Job: 2012-08-4860-CH OF USE - UNE Intermodal Transportation Commercial - 172 Bishop Street (172 BISHOP ST) - InReview

Proposed Use/Work - to change the use from an Asphalt plant
to an Intermodal facility with 300 capacity
and 17' x 18' bus shelter

**RE: University of New England – Patient Care Center
Application #2012-483; CBL 145-B-024
Intermodal Transportation Facility at 172 Bishop Street**

PH101

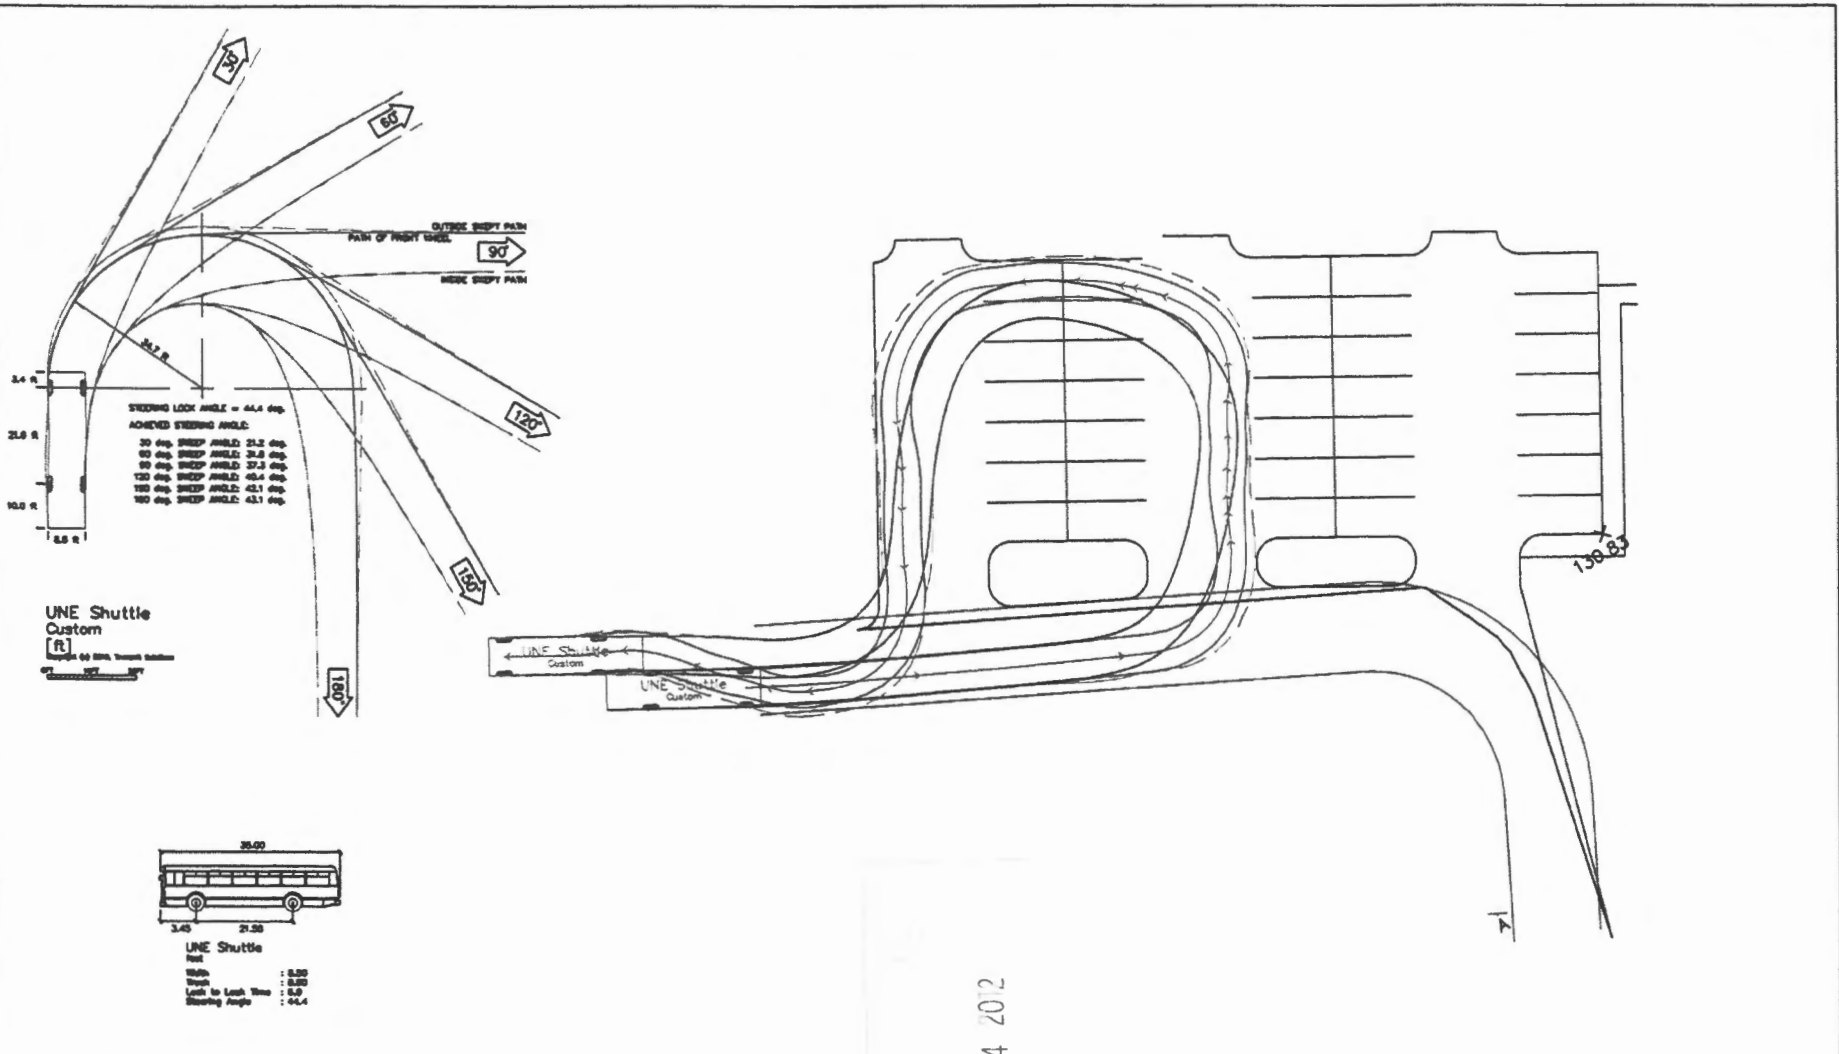
The University acknowledges that the lighting layout photometrics exceeds the city standard for maximum illumination levels. With the remote nature of the Intermodal Transportation Facility and the fact that it will be utilized at night, the University respectfully requests a waiver to the 12.2.3 Illumination Levels standard, at this location. Please see the revised PH.01 Photometry Plan, dated 09/06/12.

The University acknowledges that the lighting layout photometrics has a small area of light trespass that exceeds the city standard. This small area is in an Industrial Zone, at the intersection of Bishop Street and Bishop Street Extension, and is directly beneath a street light. With the remote nature of the Intermodal Transportation Facility, the University respectfully requests a waiver to the 12.2.5 Light Trespass standard, at this specific location. Please see the revised PH.01 Photometry Plan, dated 09/06/12.
